PLANNING AND ZONING COMMISSION PUBLIC HEARING MEETING
CITY HALL, 385 SOUTH GOLIAD STREET, ROCKWALL, TEXAS
FEBRUARY 10, 2026 IN THE CITY COUNCIL CHAMBERS AT 6:00 PM

(3) **P2025-045 (HENRY LEE)**

(4) **SP2025-048 (HENRY LEE)**

SHEET 4 OF 6 XE-8
 SHEET 3 OF 6 555.64

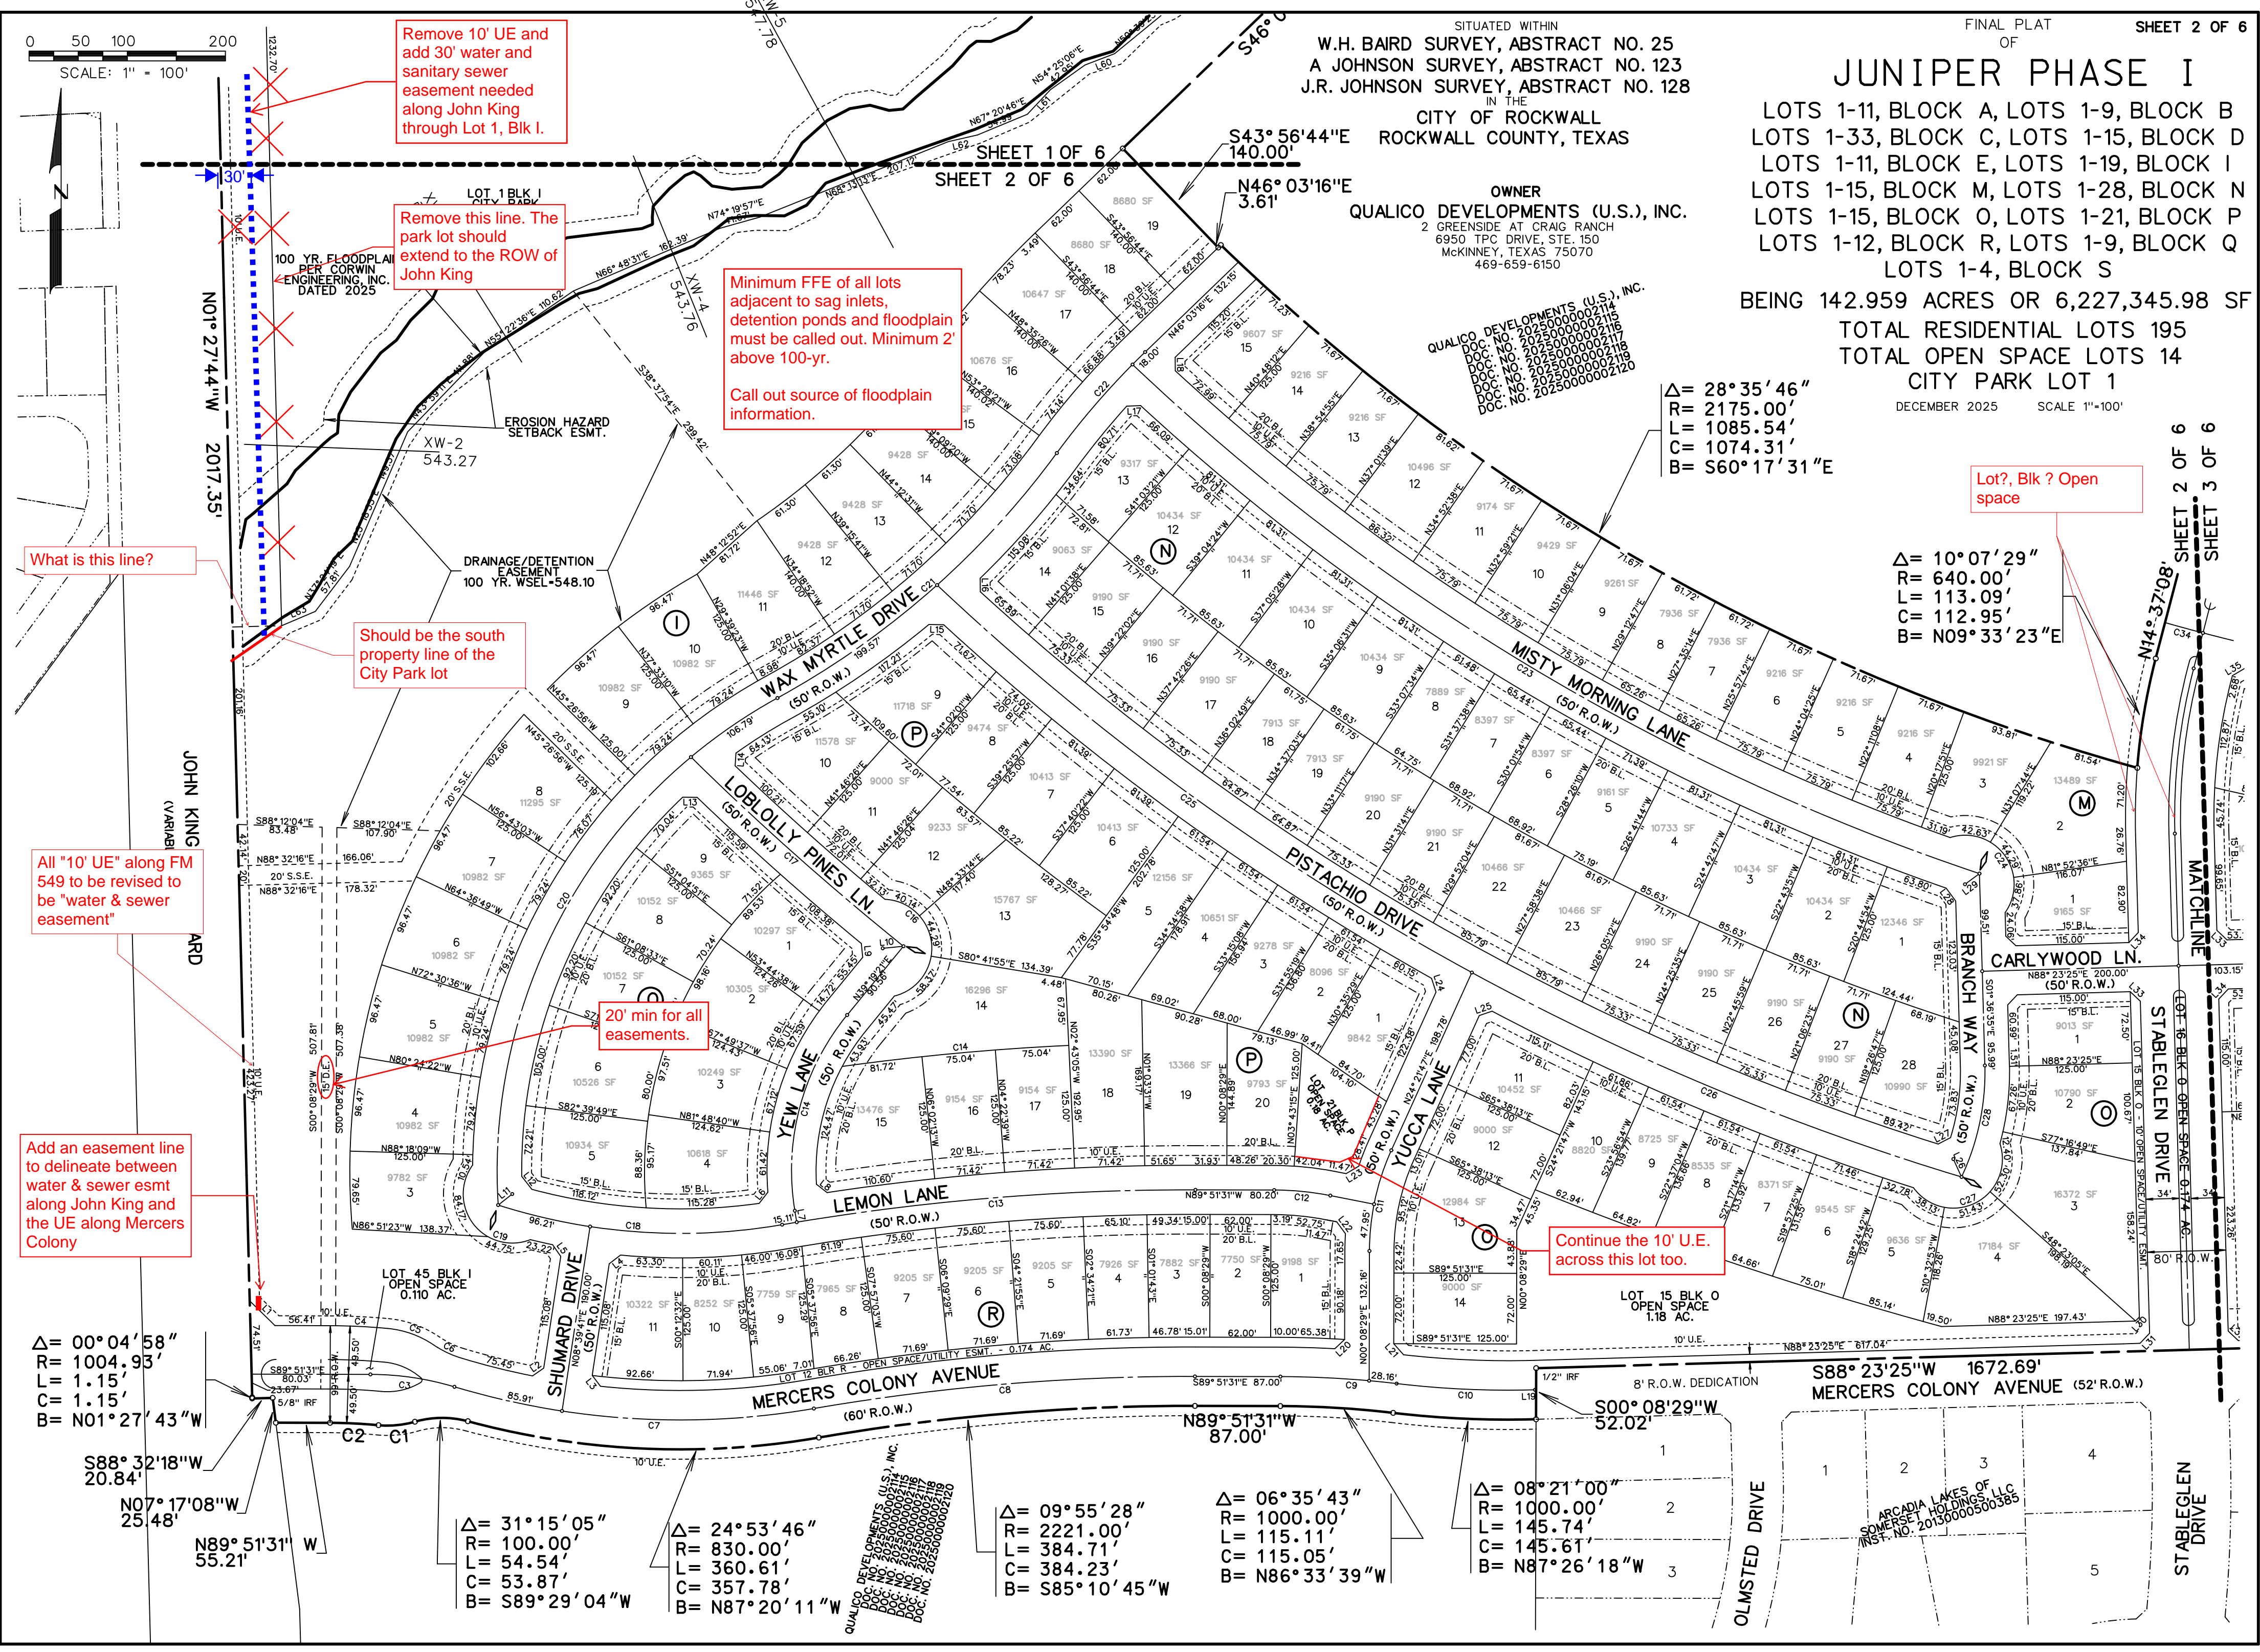
Match lines don't
 "match" location
 between Sheet 2 and
 Sheet 3

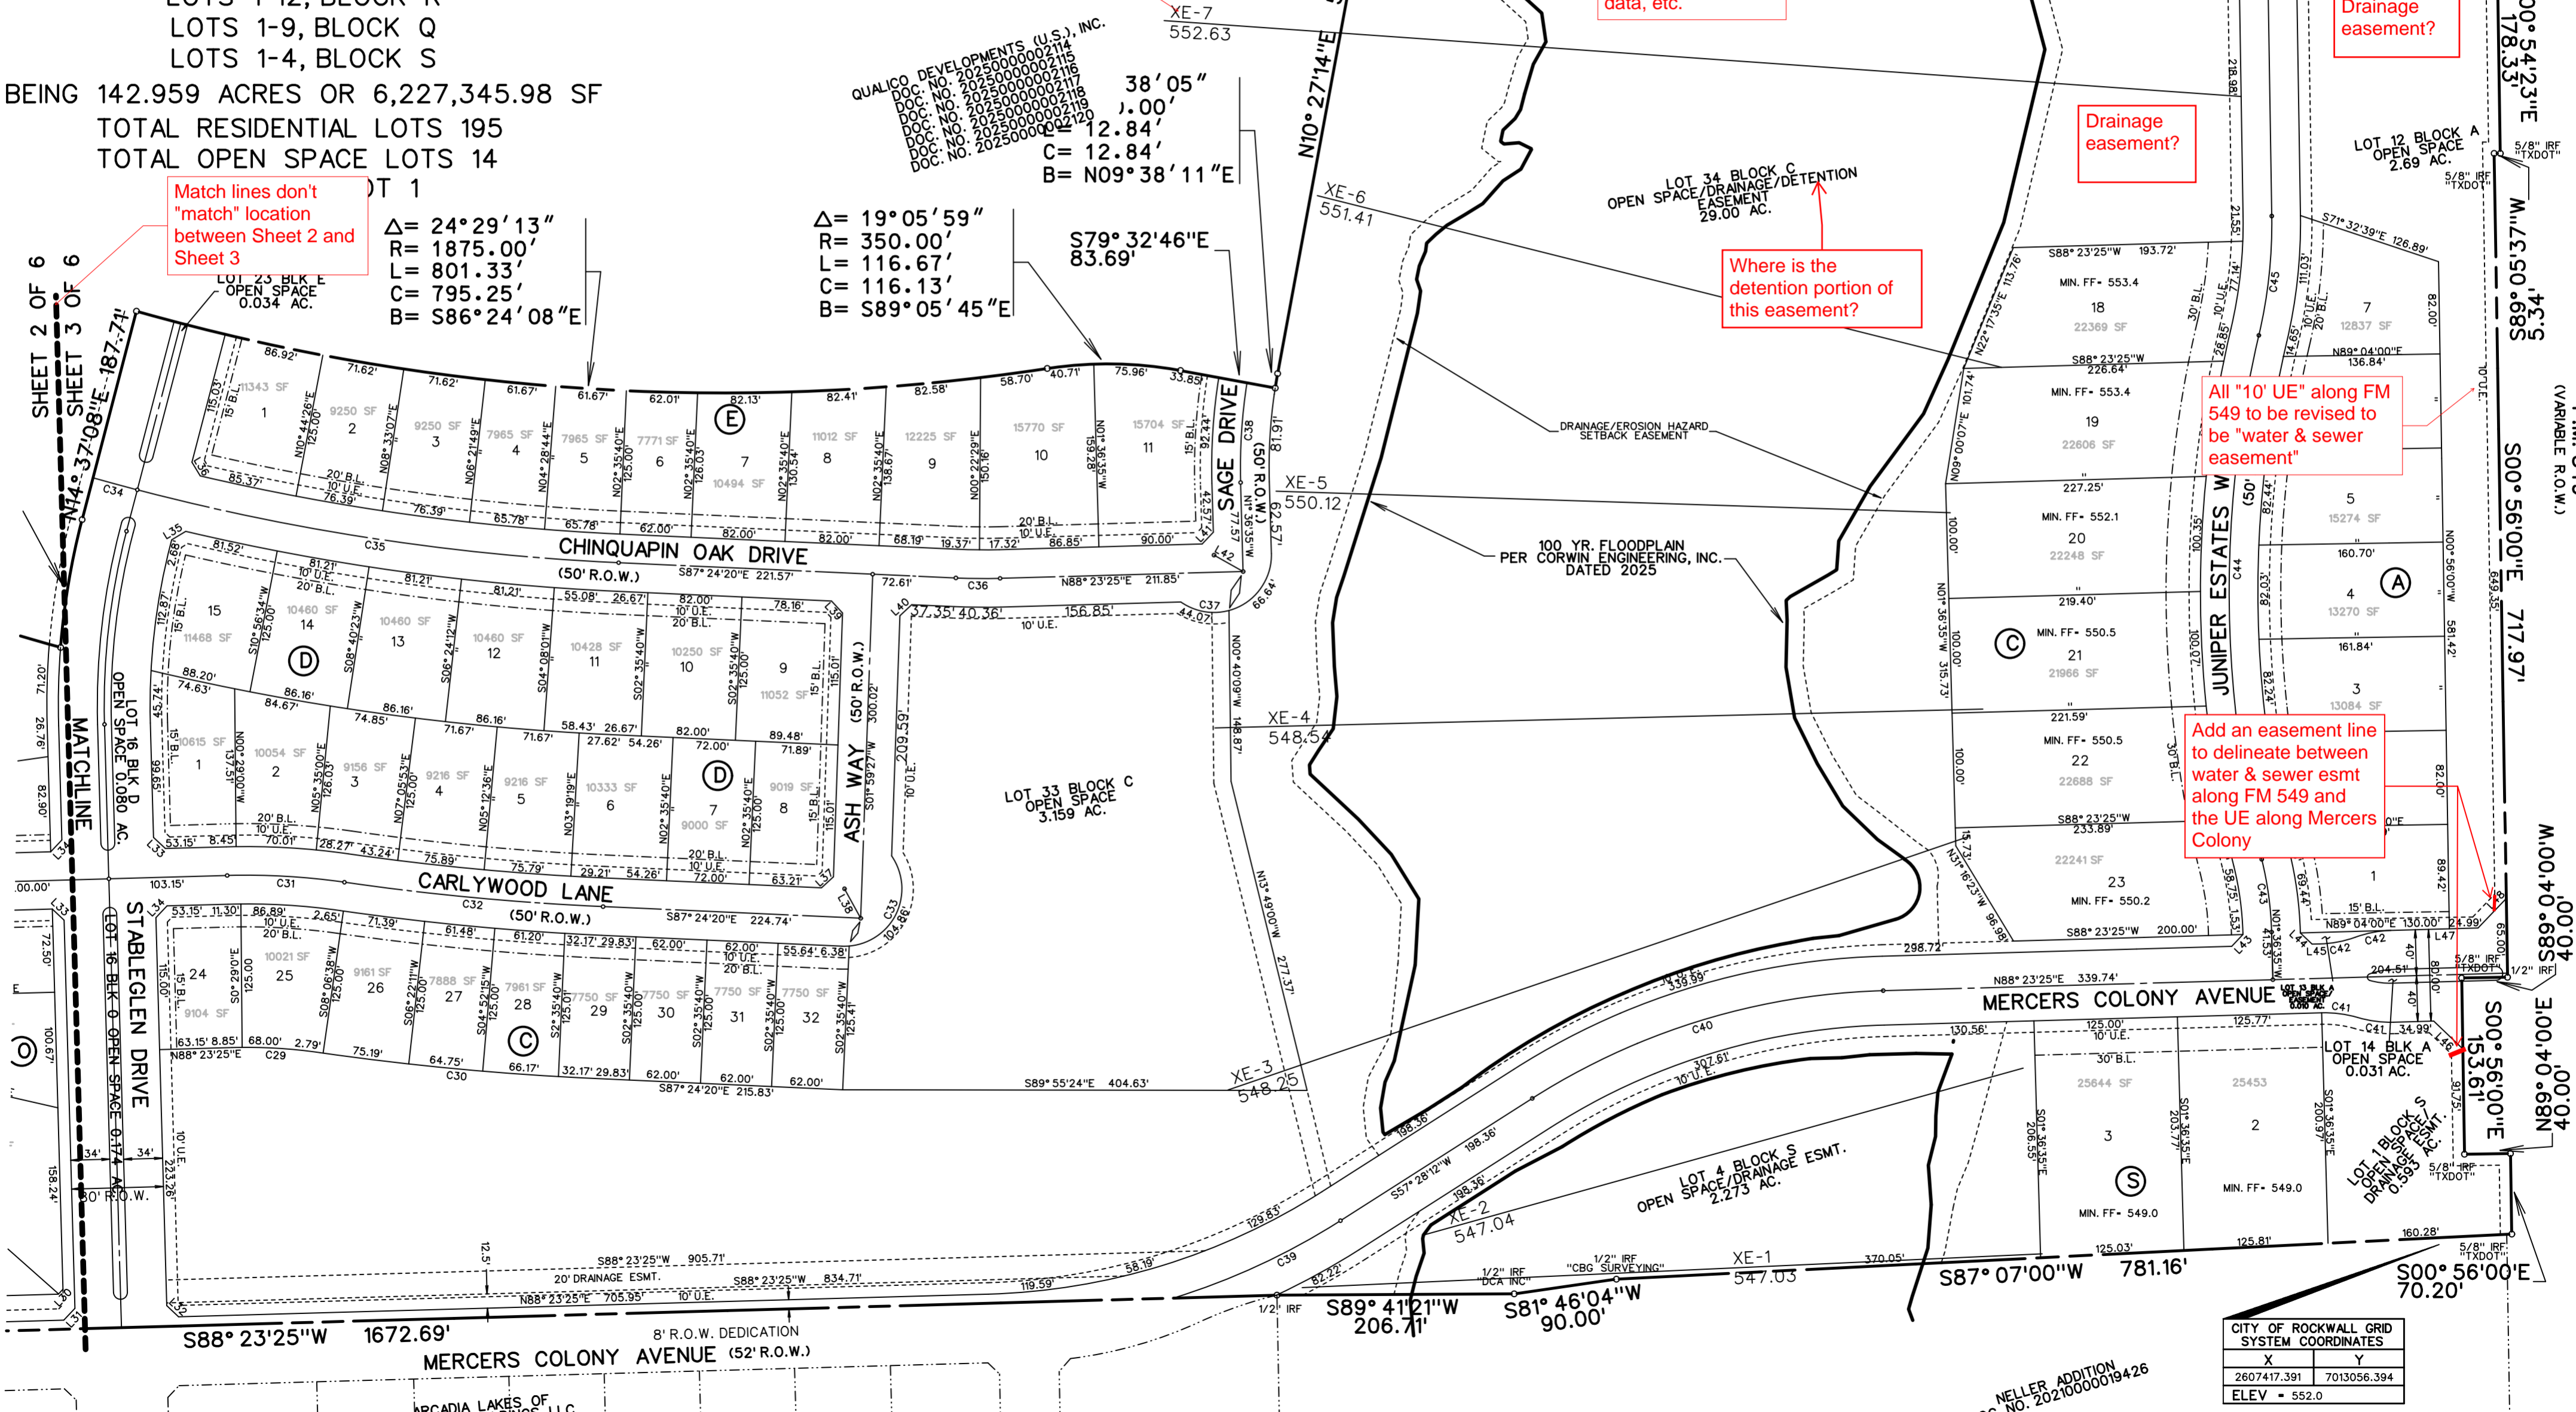
Entire easement
 needs callouts,
 dimensions, curve
 data, etc.

Drainage
 easement?

Drainage
 easement?

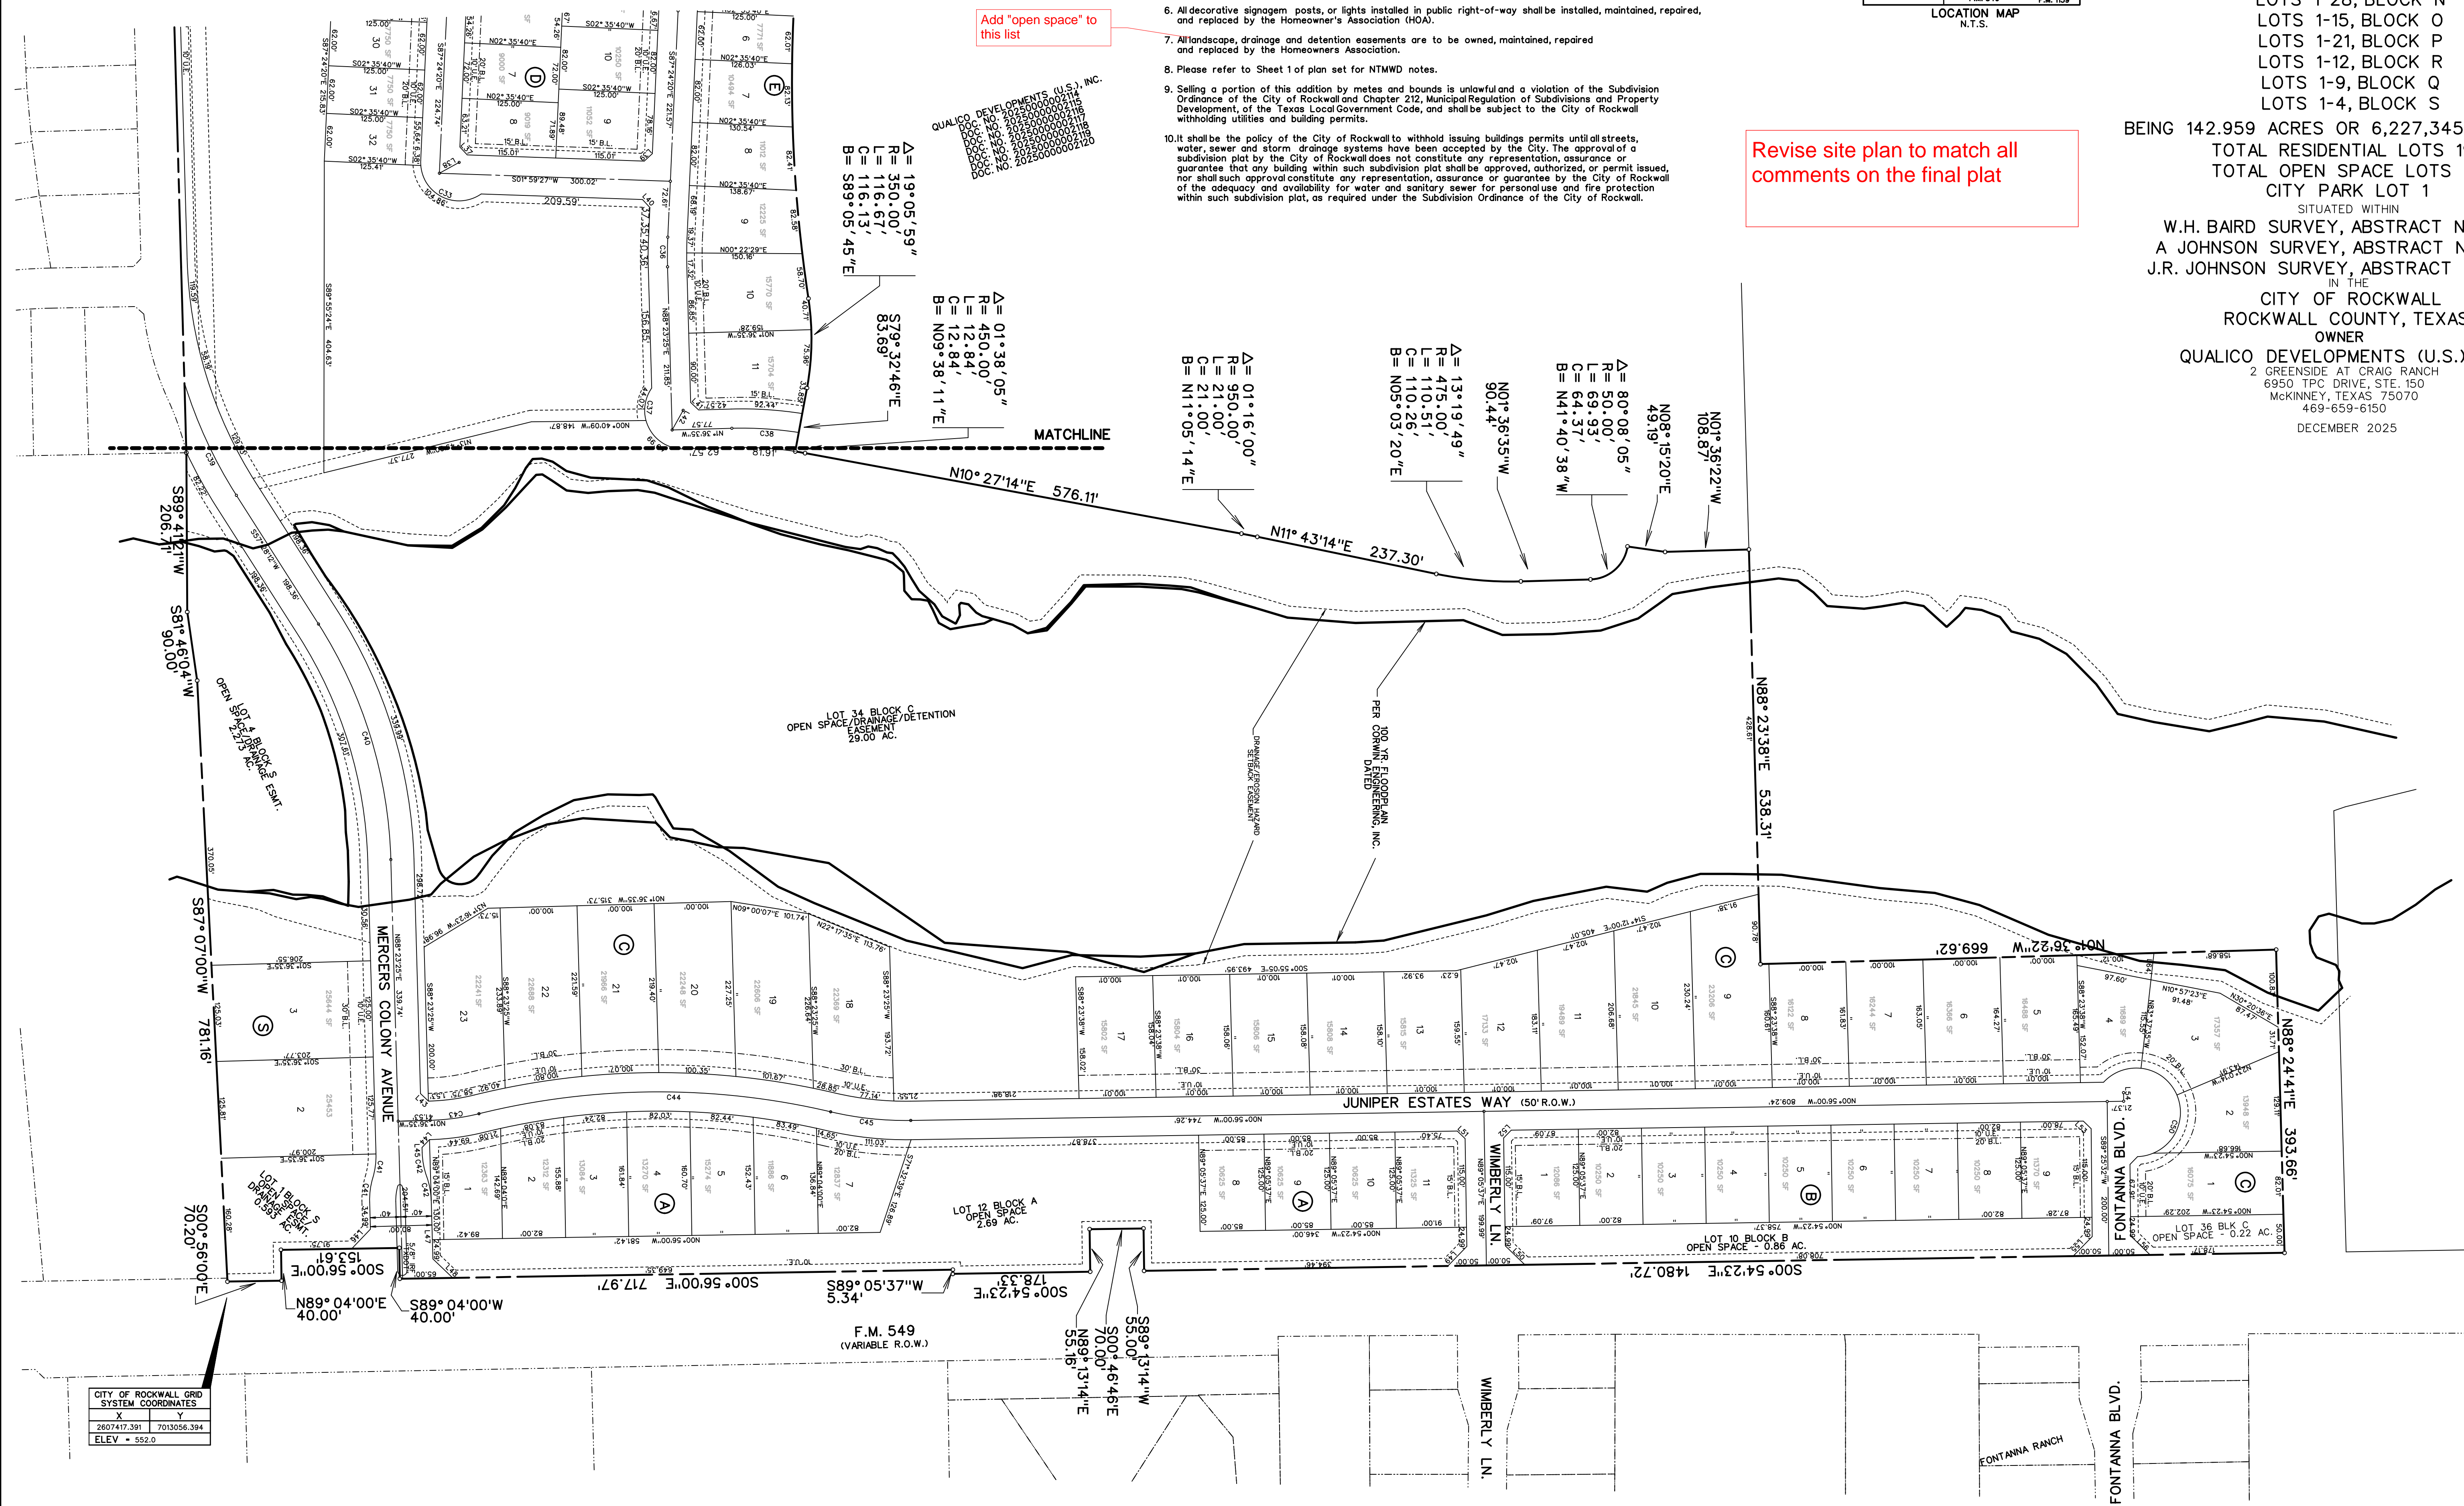
Revise site plan to match all comments on the final plat

Add "open space" to this list
